DESIGN CONFIDENCE

ESQ 1818 Panthers Pty Ltd

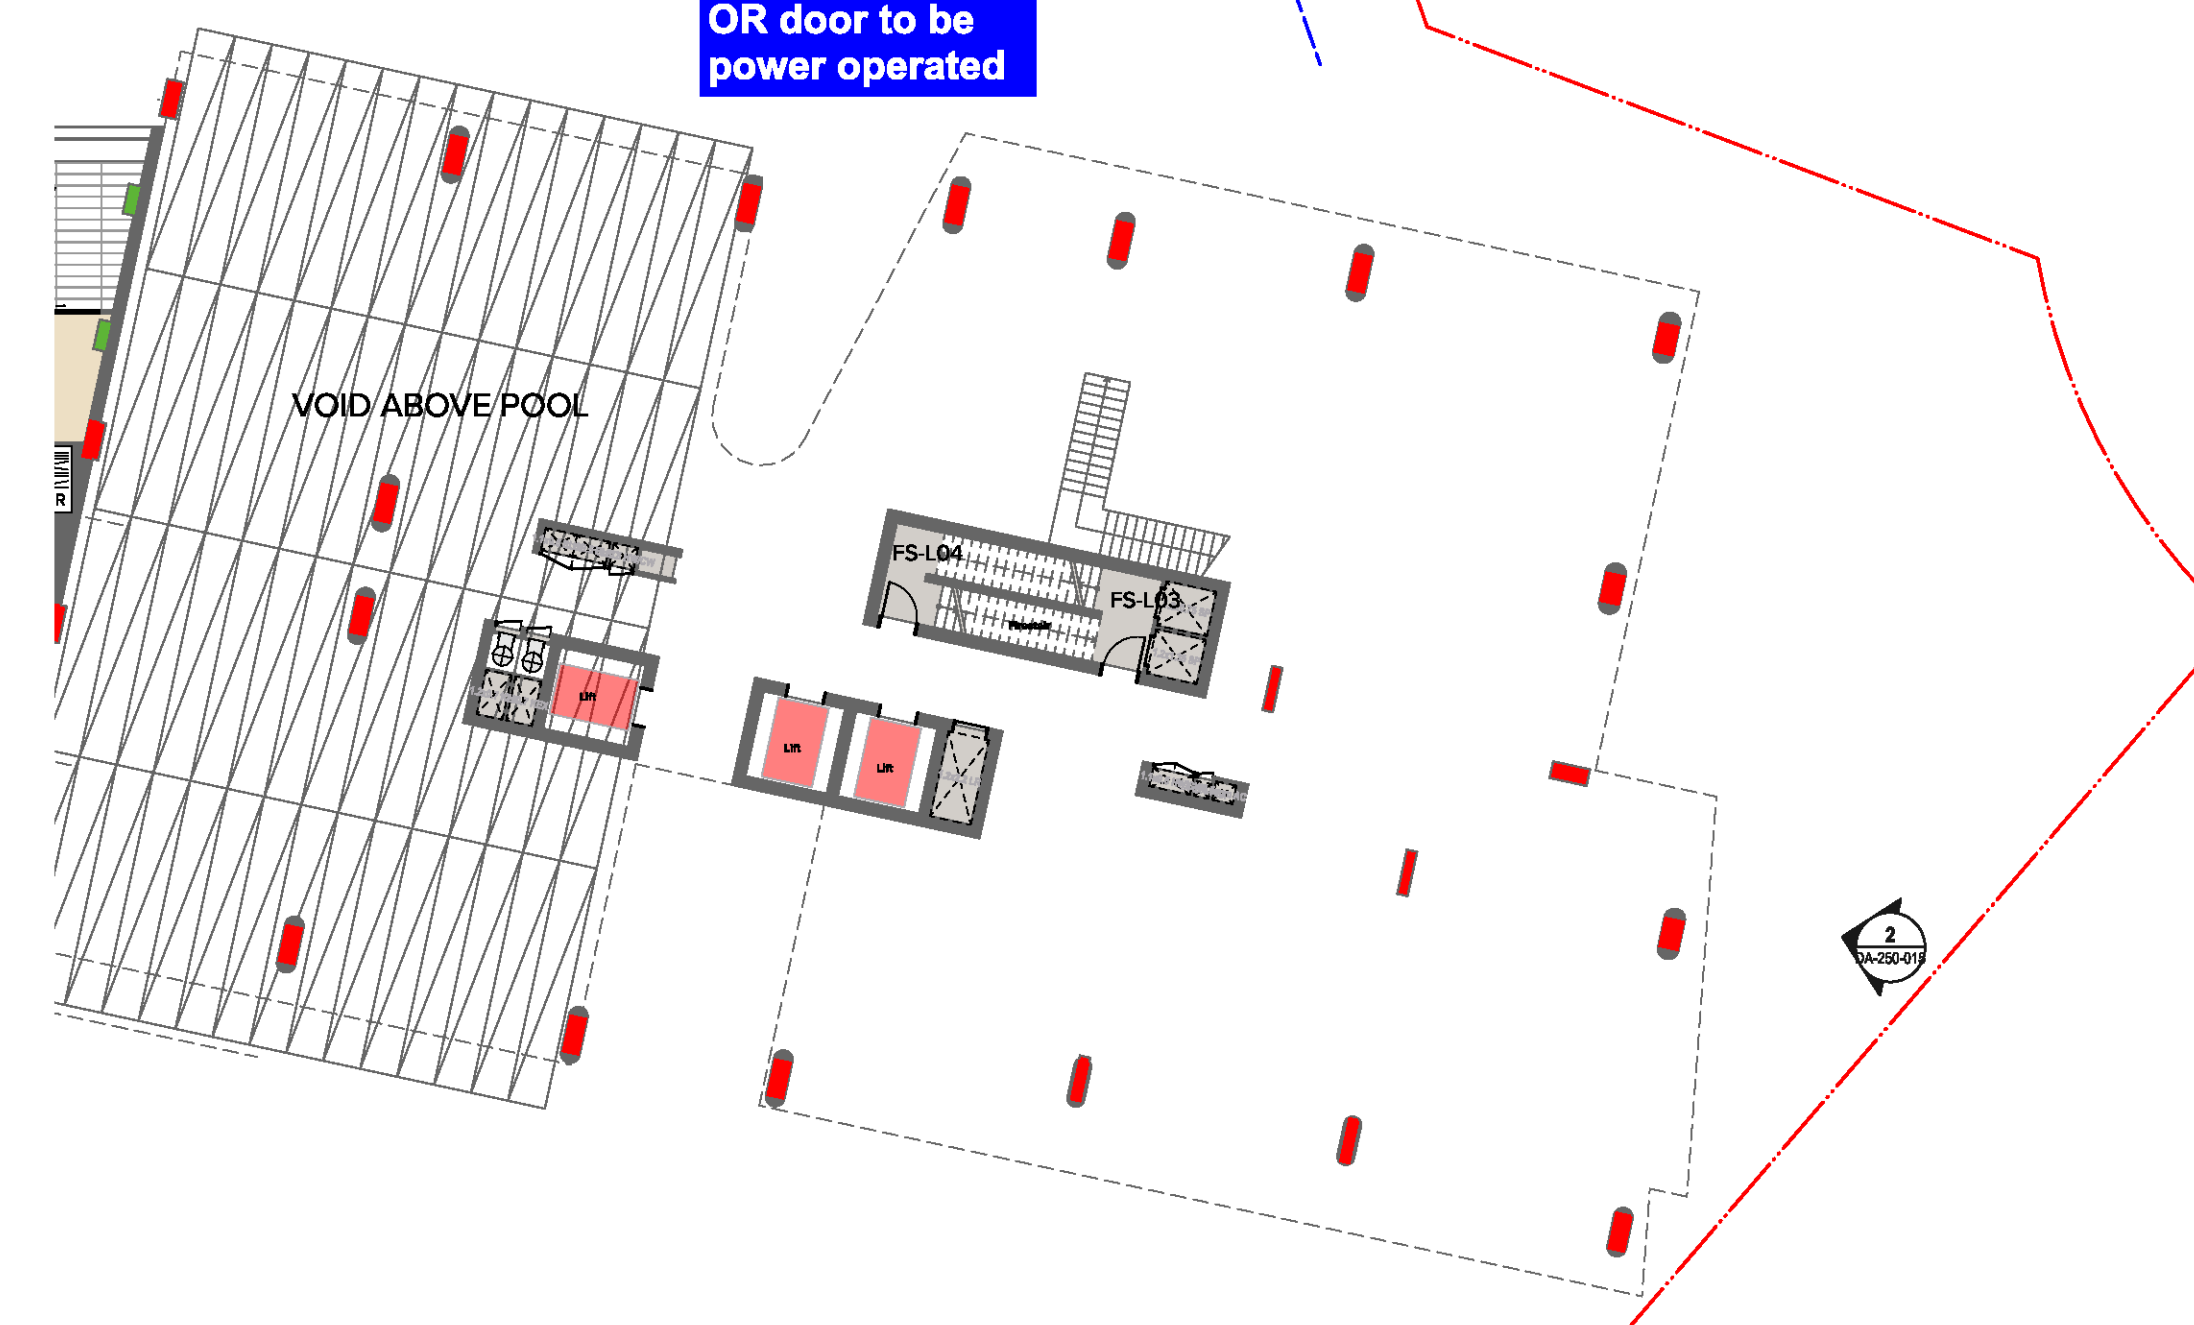
NOTES
THIS DRAWING IS COPYRIGHT © OF TURNER. NO REPRODUCTION WITHOUT PERMISSION. UNLESS NOTED OTHERWISE THIS DRAWING IS NOT FOR CONSTRUCTION. ALL DIMENSIONS AND LEVELS ARE TO BE CHECKED ON SITE PRIOR TO THE COMMENCEMENT OF WORK. IN THE EVENT OF ANY DISCREPANCIES FOR CLARIFICATION BEFORE PROCEEDING WITH WORK, DRAWINGS ARE NOT TO BE SCALED. USE ONLY POLARISED DIMENSIONS. REFER TO CONSULTANT DOCUMENTATION FOR FURTHER INFORMATION. PC AND BIM FILES ARE UNCONTROLLED DOCUMENTS AND ARE ISSUED FOR INFORMATION ONLY.
